**Cambridge Waste Water Treatment Plant Relocation Project**  
Anglian Water Services Limited

# Applicant's responses to ExA Hearing Actions

Application Document Reference: 8.20

<b>Document title</b>	Applicant's responses to ExA Hearing (CAH1 and ISH3) Actions
<b>Version No.</b>	01
<b>Date Approved</b>	22.01.23
<b>Date 1<sup>st</sup> Issued</b>	22.01.23

**Local diversion of  
Horningsea Road whilst  
pipes are laid in that  
location**

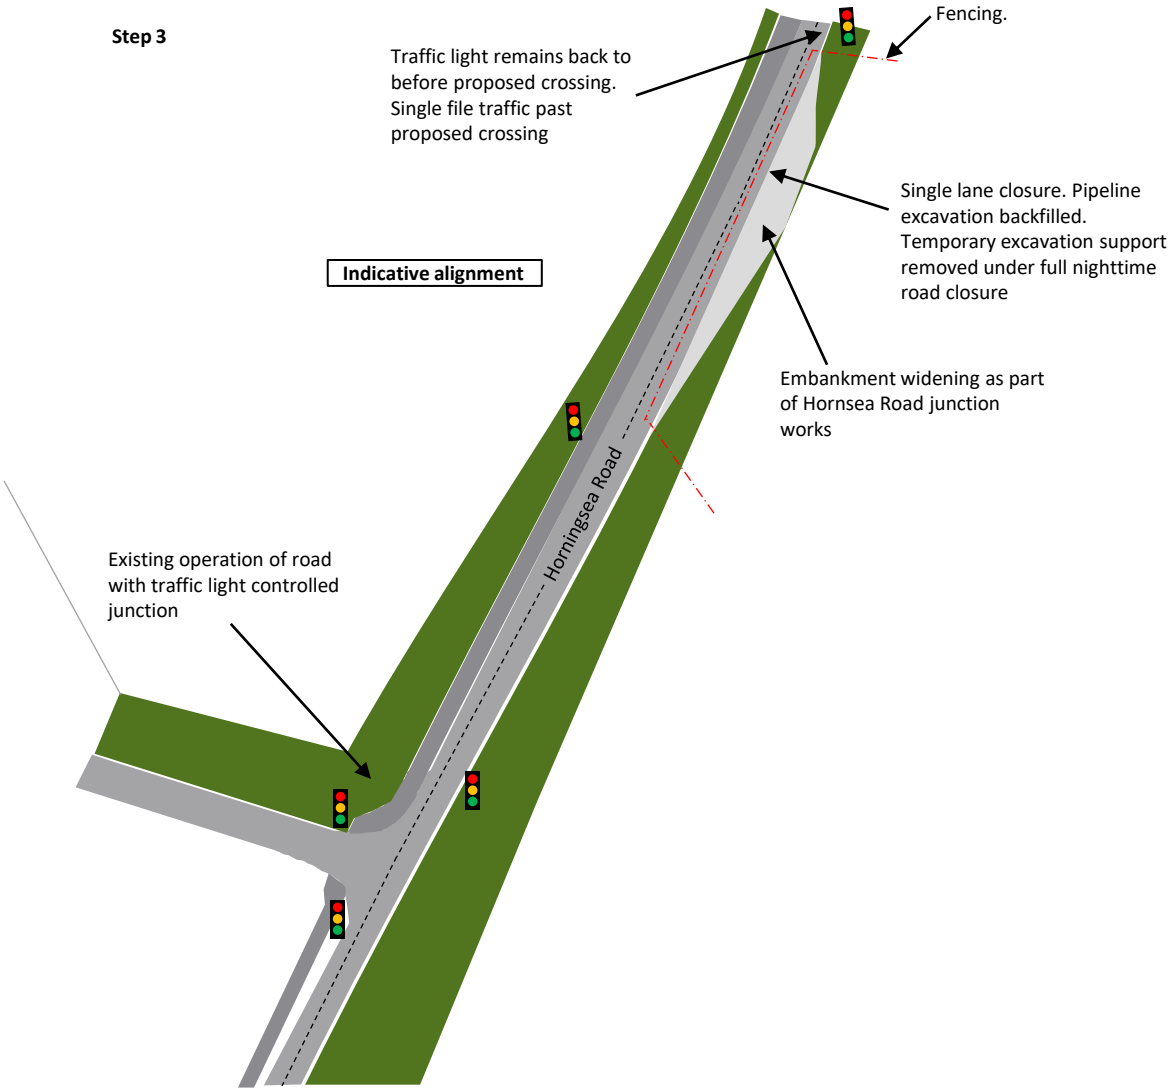
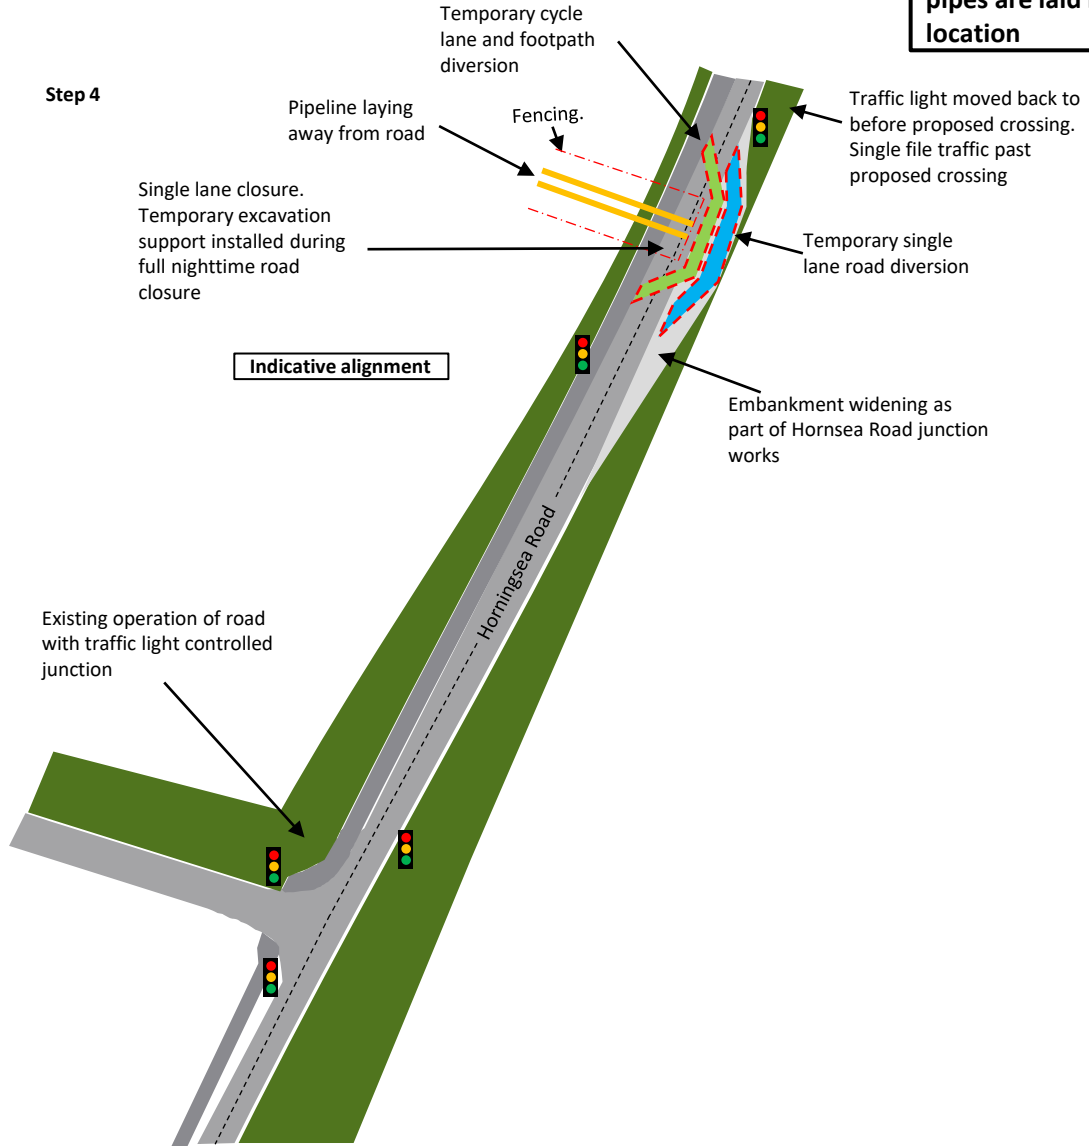
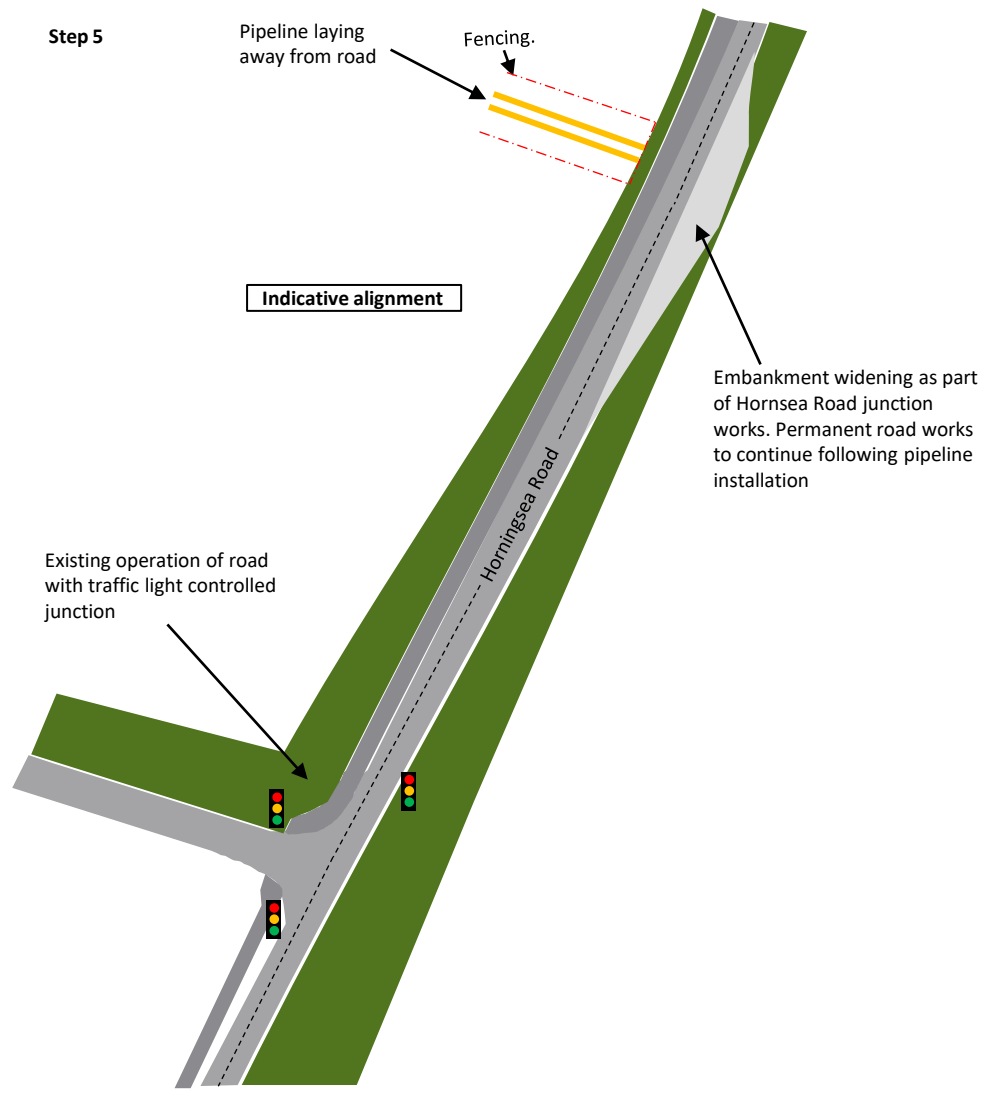
***Details relating to how potential trenching across PRow and Horningsea Road would take place and whether this would result in short-term closures of PRow, bearing in mind the routes of diversions shown on the Rights of Way Plans [REP1-018] run adjacent to / parallel with PRow which cross potential trenching works.***

Article 17 of, and Schedule 9 to, the dDCO permit the Applicant to temporarily regulate traffic in order to construct the Proposed Development. This includes the power to prohibit certain vehicular movements, control the direction of road users and restrict access. Sheet 3 of the Access and Traffic Regulation Plans (App Doc Ref 4.7) [AS-154] identifies the location of temporary traffic regulation measures required for the installation of the Final Effluent and Stormflow Pipelines across Horningsea Road.
